# Service Update

## 18046 Motor Generator Unit Coolant Hose

Reference Number: N182148600

Release Date: March 2018  
Revision: 00

4971033

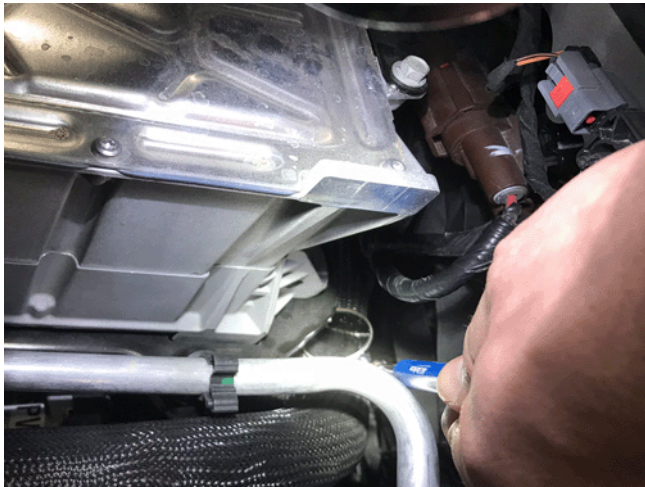
<b>Condition</b>	On certain 2018 model year Buick LaCrosse vehicles, the motor generator unit (MGU) coolant hose may contact the battery power inverter module (BPIM). Customers may experience a coolant leak.
<b>Correction</b>	Dealers are to install a shorter bolt. They should also inspect the coolant hose for damage and replace it as necessary.

1. Inspect the generator control module coolant tank hose and verify there has been no damage to the hose from the generator control module bracket bolt.
  - If there is no damage, remove and replace the generator control module bracket bolt. Torque to 22 +/- 3 Nm (16 +/- 3 lb-ft).
  - If the hose is damaged, replace the generator control module coolant tank hose (refer to *Generator Control Module Coolant Tank Hose Replacement* in SI) and replace the generator control module bracket bolt. Torque to 22 +/- 3 Nm (16 +/- 3 lb-ft).
